OCMULGEE ASSOCIATES, INC.

February 16, 2001

Reference: Stonehurst, Paine Estate, Waltham, Massachusetts  
OA File 20016.1

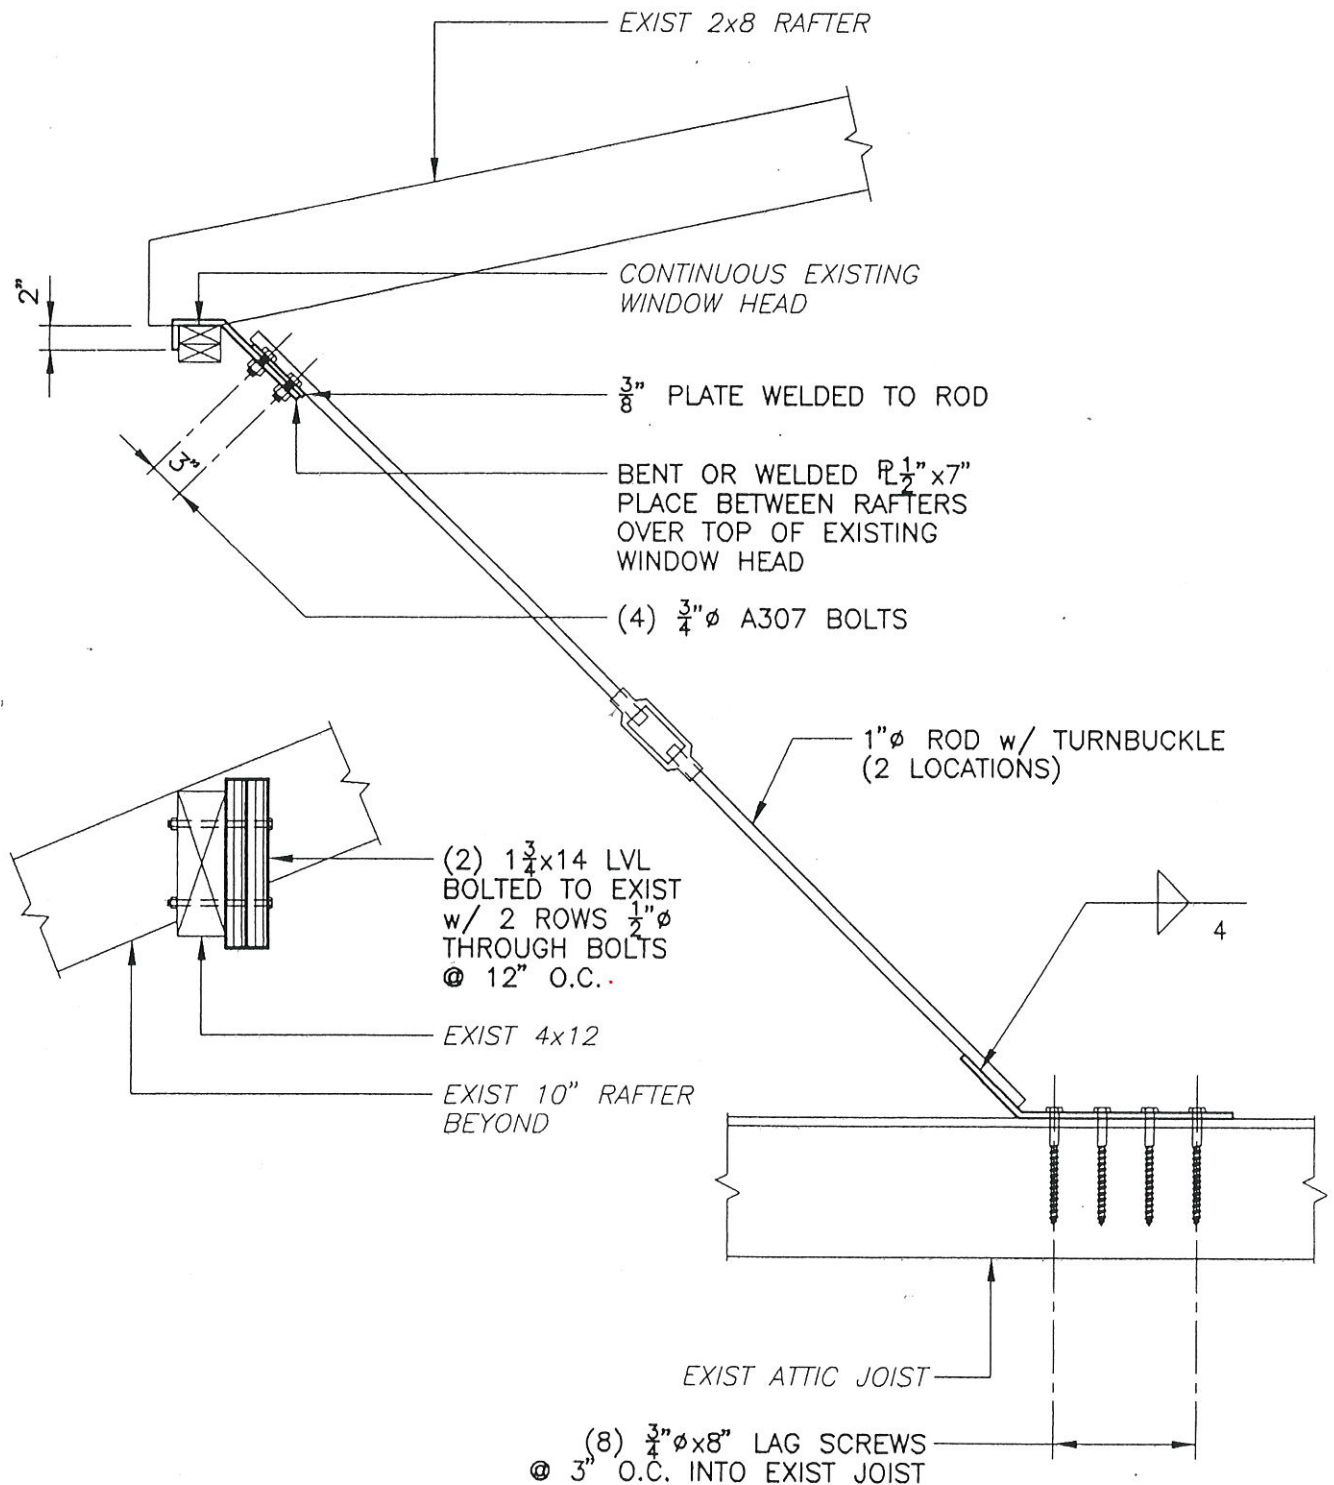
3. The window wall of the south-facing shed dormer has leaned outward. The wall and the portion of the roof sitting on the wall are not supported on the attic floor but rather on a low 4x12 header beam under the windows. The beam frames into the rafters on both sides of the dormer. If the full 30 psf snow load is placed on the roof, the beam would be severely overstressed. As a practical matter, the snow probably slides off the metal seam roof before it can significantly accumulate.

The tilt in the window wall is probably not related to the undersized beam. Because there is no ridge beam, the roof is unbalanced. The steeply sloping north roof leans against the shallowly sloped dormer roof and pushes it over. Theoretically, the roof framing is unstable at the shed dormer. However, the roof sheathing probably redistributes the loads and restrains further movement.

We recommend that the 4x12 beam under the windows be reinforced with two 1-3/4"x14" sisters and that diagonal steel tie-rods be added in the attic space to brace the window wall. The tie rods would go from the top of the window wall down to the attic floor at about a 45 degree angle.
